UNITED STATES PATENT AND TRADEMARK OFFICE

APPLICATION NO.	FILING DATE	FIRST NAMED INVENTOR	ATTORNEY DOCKET NO.	CONFIRMATION NO.
10/586,423	04/18/2008	Sriskanthan Nadarajah	RAJAH4.001APC	4863

Office Action Summary	Application No. 10/586,423	Applicant(s) NADARAJAH ET AL.	
	Examiner Khanh Dang	Art Unit 2111

DETAILED ACTION

FIG. 1

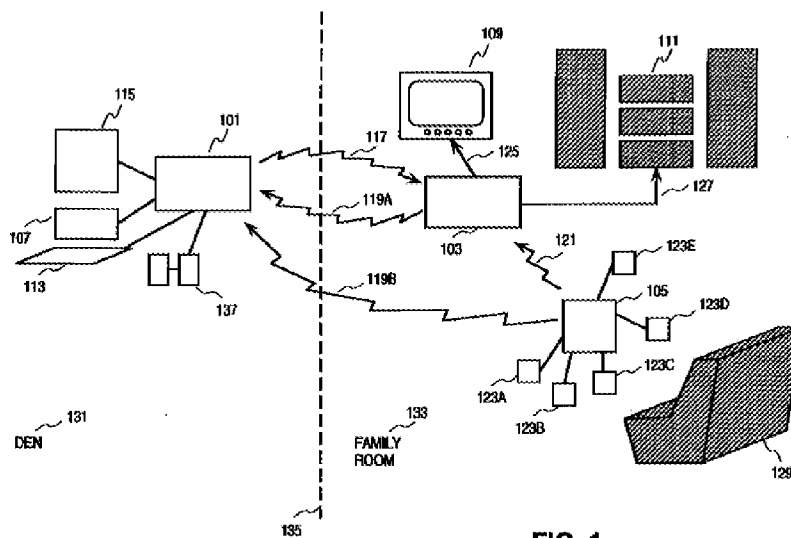
With regard to claim 1, Yiu discloses an interface for interfacing a digital device (unit) for transmitting and/or receiving a digital stream to a computer (as shown generally in Fig. 1, which is reproduced below for ease of reference and convenience, Yiu discloses an interface for interfacing a digital device for transmitting/receiving a digital video and audio stream)

, the interface comprising: a digital stream transmitter/receiver for transmitting digitally streamed content and/or receiving digitally streamed content to/from the digital device (the transceiver 459 is readable as the so-called “digital stream transmitter/receiver”. See at least column 2, line 42 to column 3, line 7; column 6, lines 16-32); a computer bus interface for receiving/providing data to/from a computer bus of a computer for use by the computer and/or as provided by the computer (it is clear that PC107 uses a computer bus interface such as interface 101); and a data converter for converting data received by the digital stream receiver into data useable by the computer when provided to the computer bus and/or for converting data received by the computer bus interface into digitally streamed data for transmission by the digital stream transmitter (converter 455 is readable as “data converter.” See at least column 6, line 33 to column 7, line 48).
